Addendum 1 to Installation Instructions for Cessna 206H and T206H
AvSpec Document Number AV4019INST

Cessna has added an alternate configuration to their 206H and T206H series aircraft. The configuration provides additional wiring for the Enhanced Vision System (EVS) camera installation, which is part of Cessna Service Bulletin SEB-34-04. This new configuration affects the installation instructions for the AvSpec 130 Amp Alternator (STC SA01782LA), as an additional power supply wire was added to the Power Junction Box (PJB) attached at circuit breaker (CB) F3.

FIGURE 1 – Diagram of PJB and circuit breaker panel

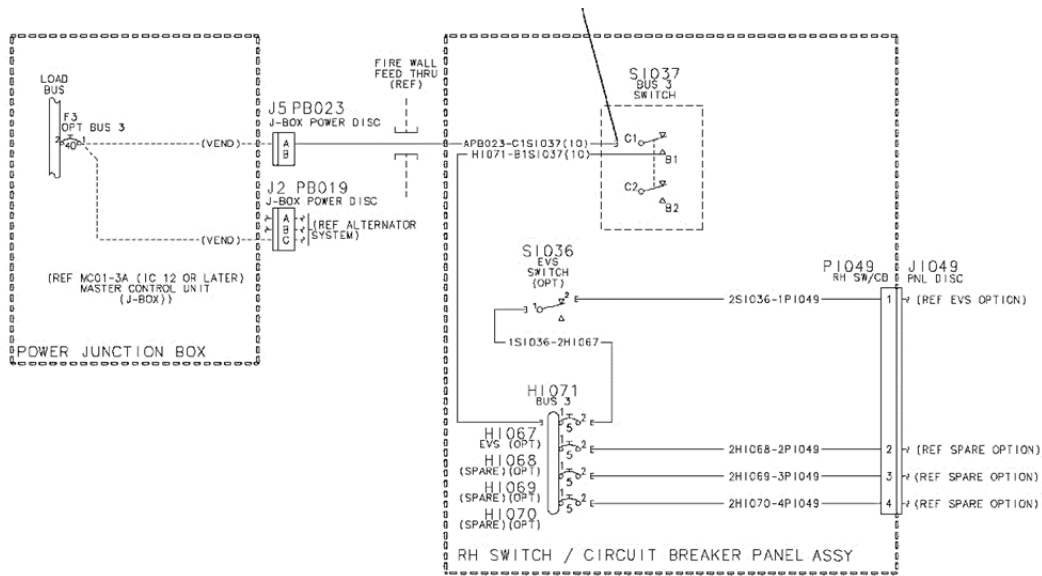
1. After replacing the three 50 Amp RCB as required for the AvSpec alternator installation, retain one of the removed 40 Amp RCB for the EVS wiring provisions. This 40 Amp RCB is to be placed between the F3 RCB and the J5 EVS two-pin connector.
2. This will require relocation of the 40 Amp RCB and adding an 8-gauge wire between the 50 Amp RCB to the 40 Amp RCB. A diagram of the OEM circuit is presented in figure 1.

4. Remove the 10-gauge electrical wire from the F3 RCB, figure 1.

FIGURE 5 – Wire routing in PJB

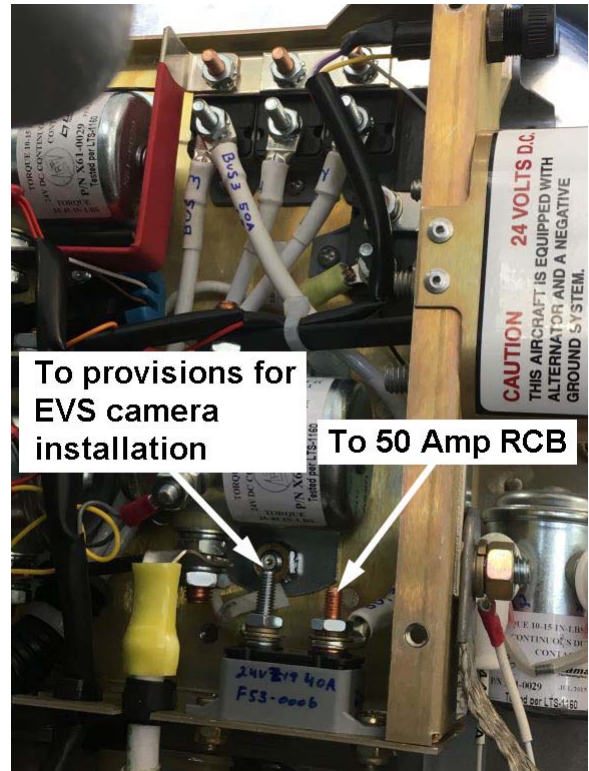
5. Relocate the original 40 Amp RCB that was replaced by the new AvSpec 50 Amp RCB to bottom of the PJB and connect to the 50 Amp RCB with the 8-gauge wire, figures 3 through 5. The 40 Amp RCB is installed with MS27039-0806 machine screws, AN960D08L washers, MS21083N08 nuts. The new jumper wire is installed from the 50 Amp RCB to the relocated 40 Amp RCB for EVS feed inside the PJB, figure 6.
